UNITED STATES PATENT AND TRADEMARK OFFICE

Office Action Summary	Application No. 10/023,474	Applicant(s) LIANG, LUKE K.	
	Examiner Carlos Lugo	Art Unit 3673

DETAILED ACTION

Attachment #1

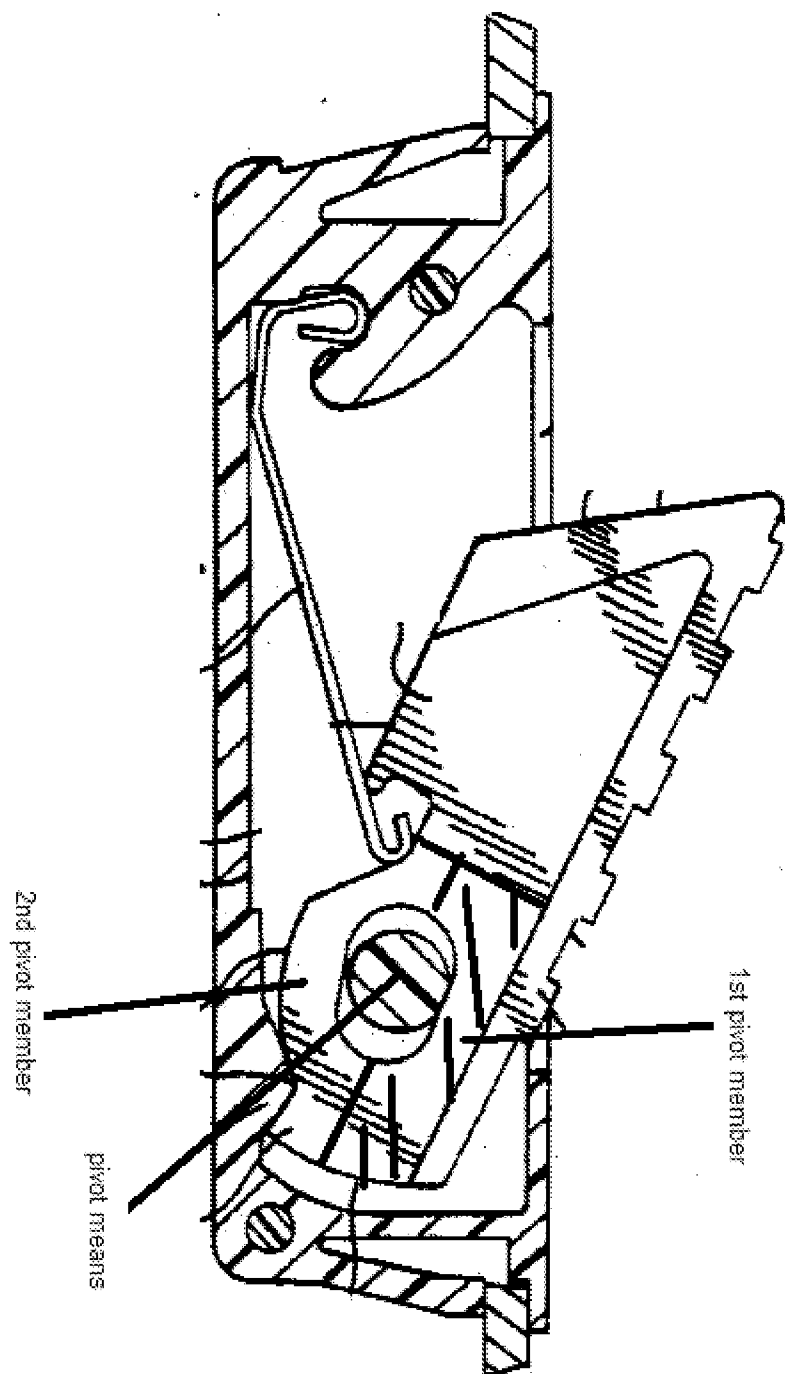
The tumbler further comprises a first pivot member that is capable of being in contact with the pivot means (38) when the tumbler is in the extended position (Figure 6, the opening contact the surface of 38), and a second pivot member that contact the bottom surface of the housing to prevent over travel of the tumbler (see attachment #1).
